PROJECT:
Department of VA
Sioux Falls, South Dakota ED Oncology
Renovation and Expansion
Sioux Falls, South Dakota

ADDENDUM NO. 002
DATE ISSUED: January 22, 2016
BIDS DUE: January 27, 2016

VA PROJECT NUMBER: 263-P-1038
TSP PROJECT NUMBER: 04121122

ITEM NO: 1: Reference Sheet 5.CD101, Site Removal and Utility Relocation Plan:

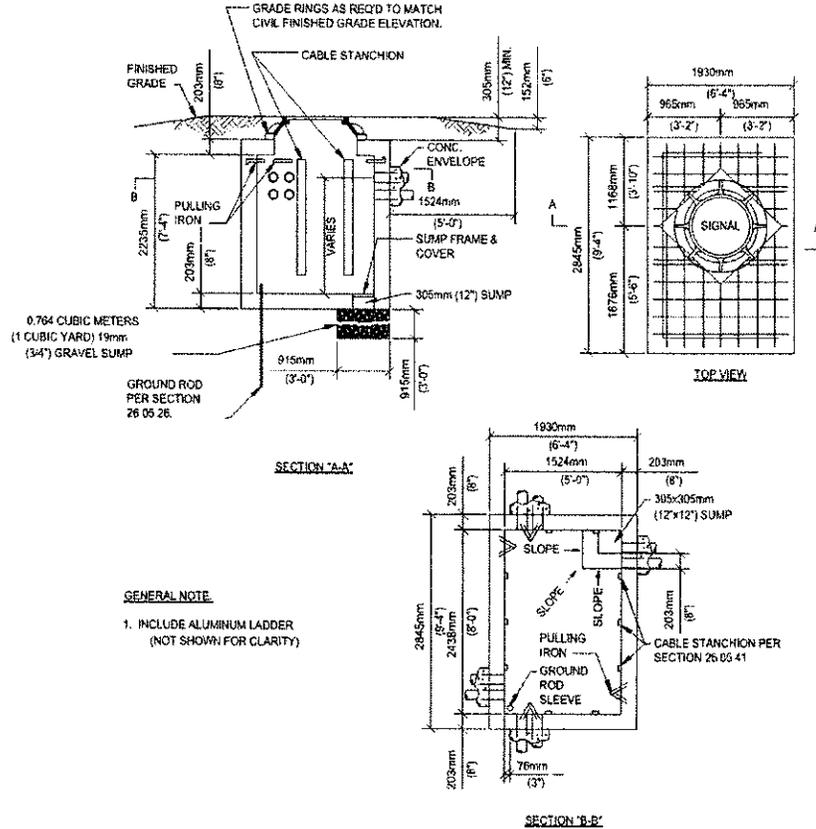
1. New Signal Duct Bank. Delete Detail reference on plan and Add the following Detail for the New Signal Duct Bank. NTS

GENERAL NOTES: 4-WAY DUCT LINE

1. CONCRETE SHALL BE 2000 P.S.I. @ 28 DAYS, OR AS SPECIFIED.
2. PROVIDE #4 REINFORCING RODS ON TOP AND BOTTOM OF DUCTS WHEN CROSSING OR PLACED IN ROADWAYS.
3. MINIMUM COVER TO TOP OF ENVELOPE SHALL BE 610mm (24") OR AS OTHERWISE SPECIFIED IN SECTION 26 05 41.
4. PROVIDE 4-INCH, 3-CELL FIBER MESH INNERDUCT.

ITEM NO: 3: Reference Sheet 5.CD101, Site Removal and Utility Relocation Plan:

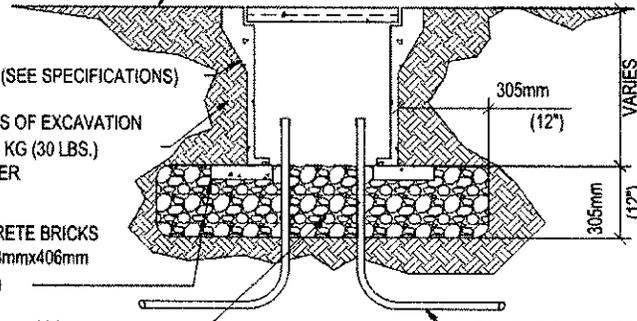
1. New Concrete Pull box. Delete Detail reference on plan and Add the following Detail for the New Concrete Pull box. NTS

GRADE. FEATHER & TAMP
BACKFILL TO CREATE FLUSH
INSTALLATION AND POSITIVE
DRAINAGE AWAY FROM BOX

PULLBOX SIZE = 12" X 18" X 26" DEEP

PULLBOX (SEE SPECIFICATIONS)

LINE SIDES OF EXCAVATION
WITH 13.6 KG (30 LBS.)
FELT PAPER

(4) CONCRETE BRICKS
51mmx203mmx406mm
(2"x8"x16")

CLEAN 19mm (3/4")
CRUSHED ROCK

CONDUIT(S) WITH BELL
ENDS (TYP), SIZE, QUANTITY
AND WIRING AS INDICATED
ON PLANS

ITEM NO: 4: Reference Sheet 5.CD101. Site Removal and Utility Relocation Plan:

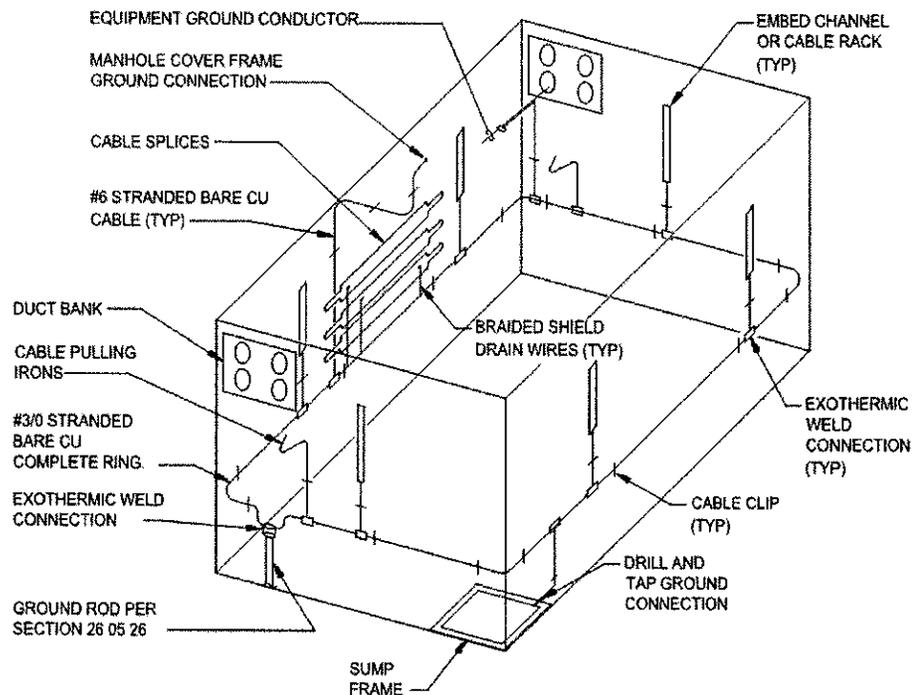
1. Manhole Grounding Detail. Delete Detail reference on plan and Add the following Detail for the Manhole Grounding Detail. NTS
